COMPANY: <Company Name>			
TITLE: <Title>			
DRAWN: TQ	DATED: 2022-3-16	CODE: -	SIZE: C
CHECKED: LC	DATED: 2022-3-16	DRAWING NO: 03	REV: 03
QUALITY CONTROL: <QC By>	DATED: 2022-3-16	SCALE: <Scale>	
RELEASED: TQ	DATED: 2022-3-16	SHEET: 4 of 5

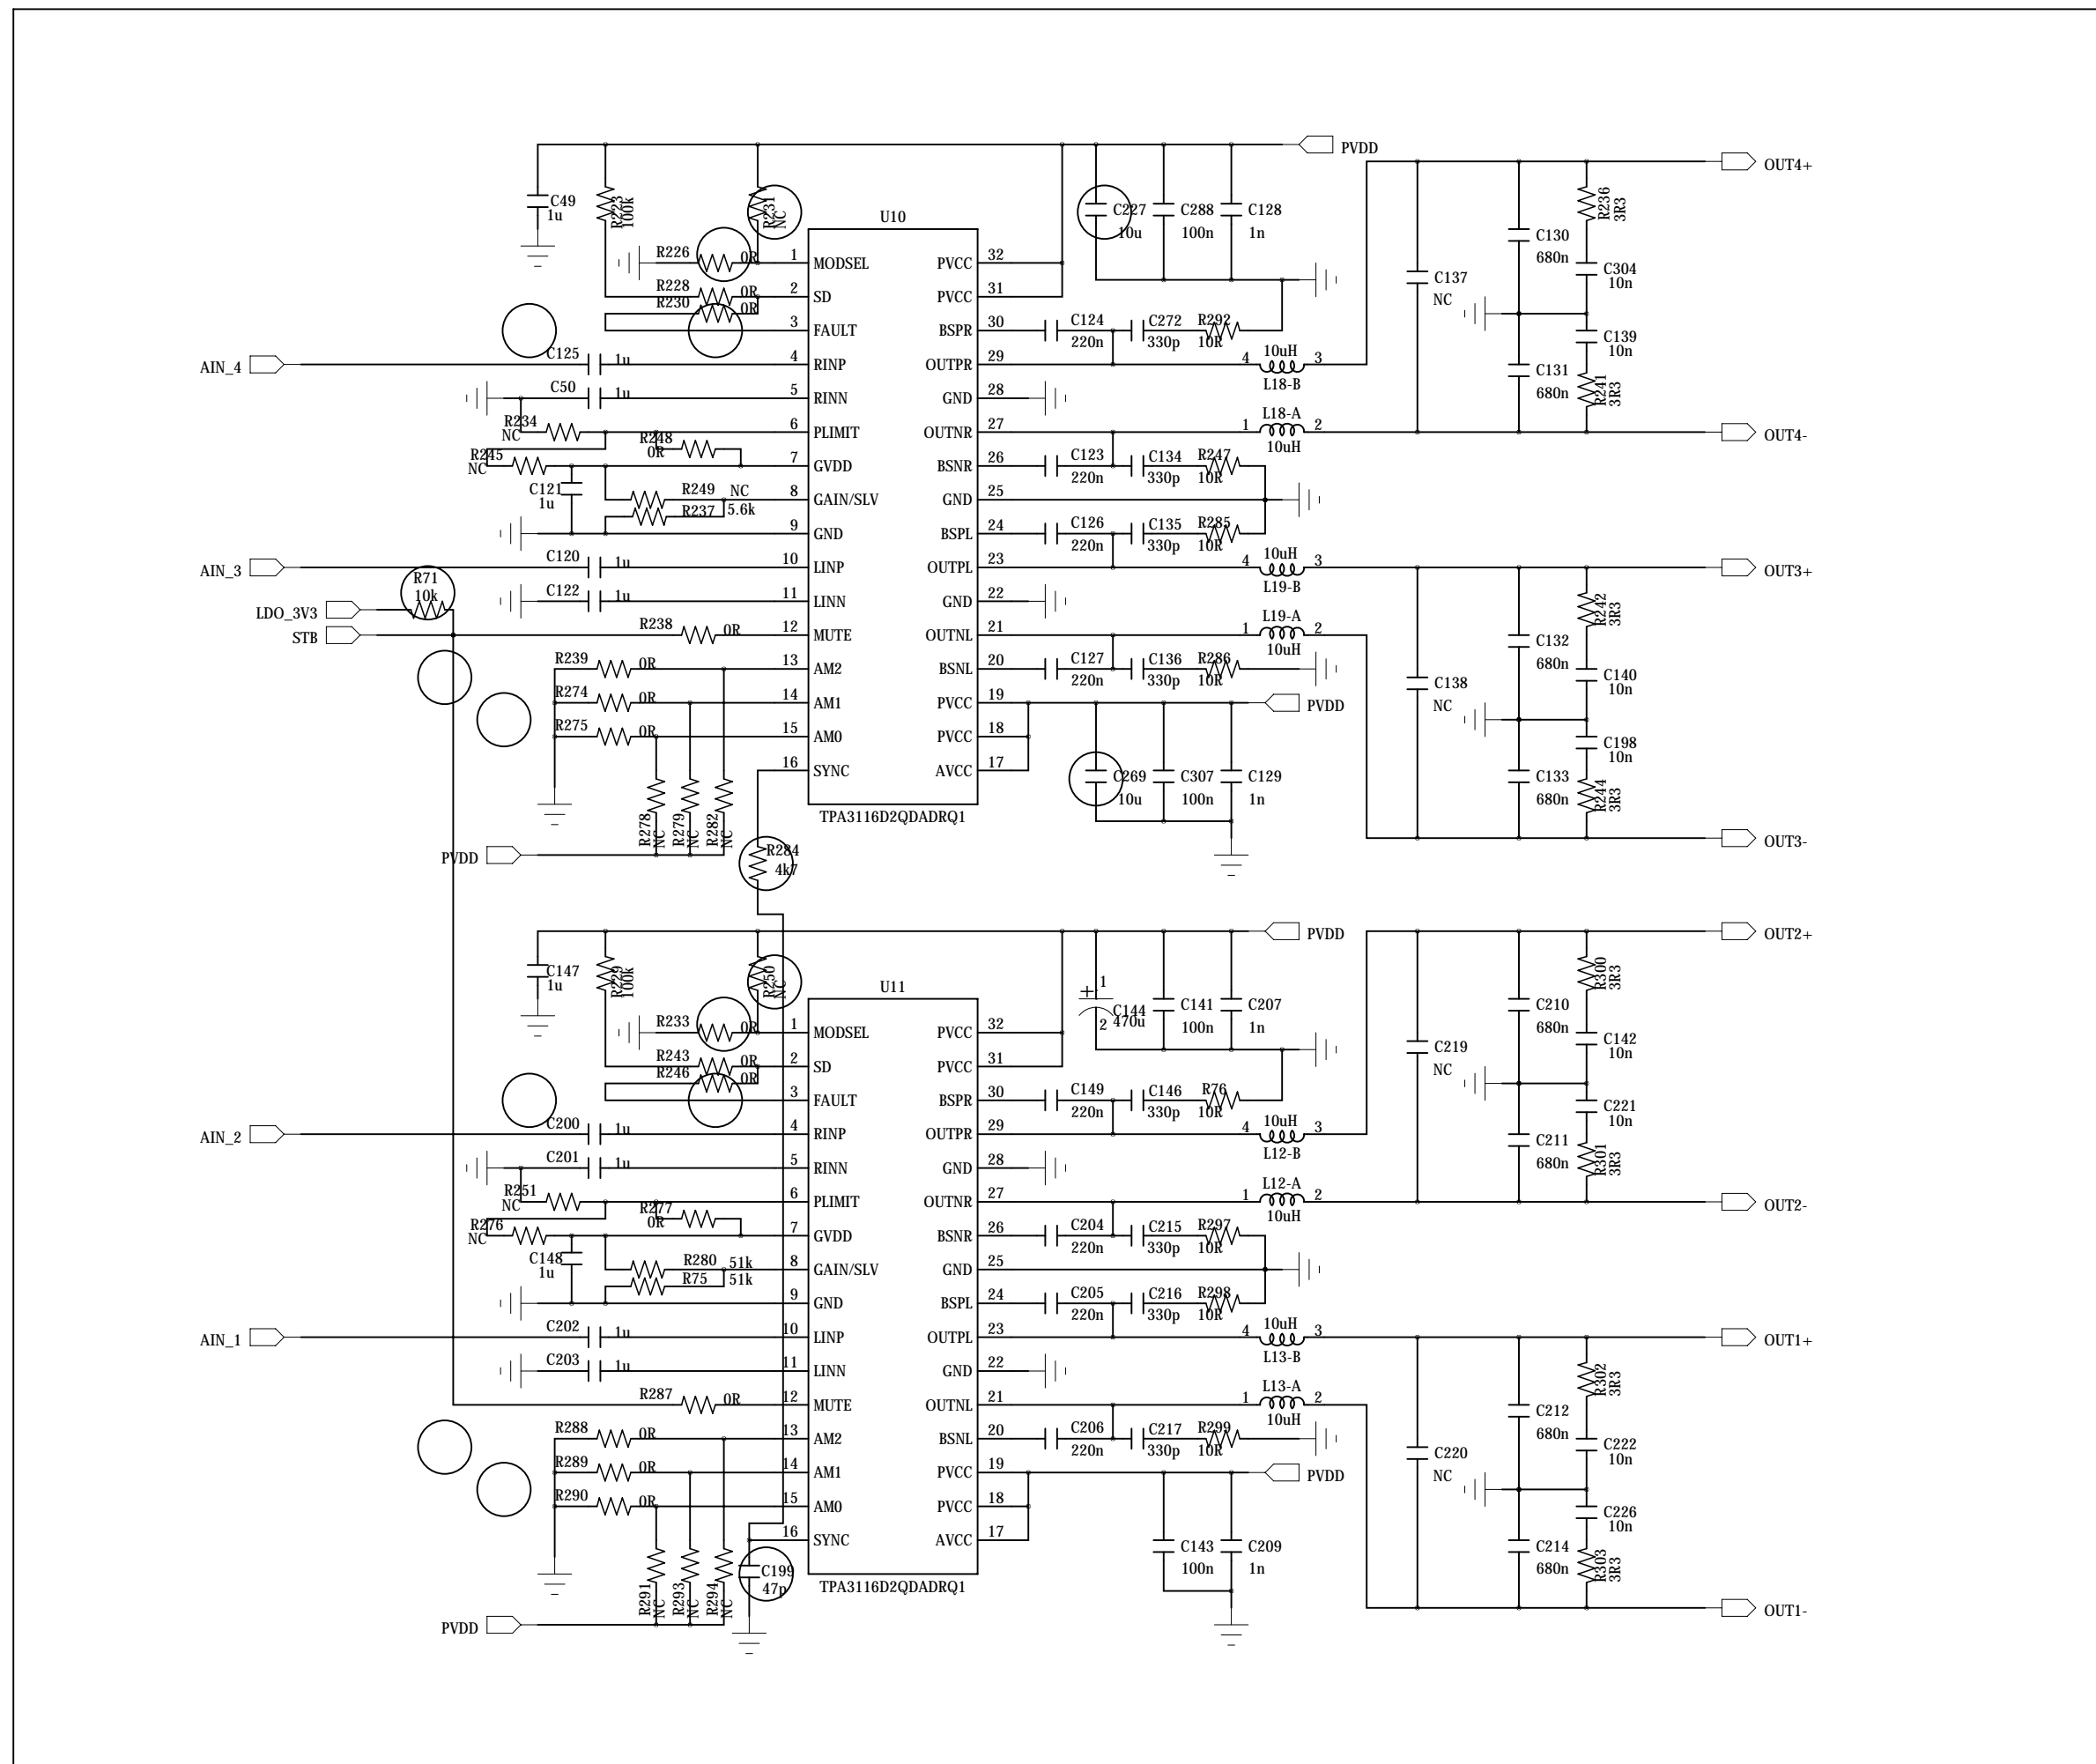
- 1.del R225
- 2.R71=10k
- 3.C227,C269 to 0603 decal
- 4.del R283,Q11
- 5.add Q8,Q10
- 6.del R295,Q12
- 7.NC R231,add R226=0R
- 8.del R227,add R230=0R
- 9.R284=4.7k
- 10.C199=47pF
- 11.del R240,add R246=0R
- 12.NC R250,add R233
